Staff Report

Project Name:	ATM & Deposit Box for the Littleton Mixed Use Building
Case Number:	COA18-0005
Building Name:	Littleton Mixed Use
Application Type:	Certificate of Historic Appropriateness
Location:	2679 W. Main Street
Applicable Design Guidelines:	Littleton Downtown Design Standards
Applicant:	Jon Benallo, 2679 W. Main Street Partners, LLC
Owner:	2679 Main Street Partners, LLC
Applicant Request:	Installation of an ATM and Deposit Box

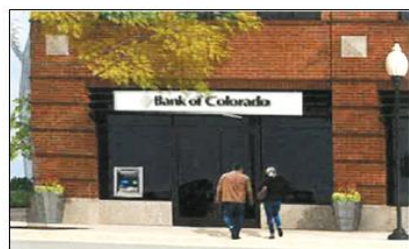
Installation of an ATM in the street-facing storefront as shown below. The face of the machine as it sits in the window is 28" x 33". The fascia will be flush with the storefront glass and the work space is recessed into the building. The machine includes backlit areas for the touch monitor and other features. Information on ATM's, including bank logos, is not considered signage regulated under the city sign code.

The ATM's proposed location on the front façade of the building will be visible to pedestrians in close proximity to the ATM in both in daytime and nighttime, due to the backlit touch monitor and other lighted features. The fascia of the exterior of the ATM will be a dark grey/dark bronze matte finish and is compatible with the metal storefront frame. The ATM work space with its various user functions and lighted elements are not characteristic of the district, but will have an insignificant impact on the historic character of the district, because of the recessed work space and visibility of the space with the district.
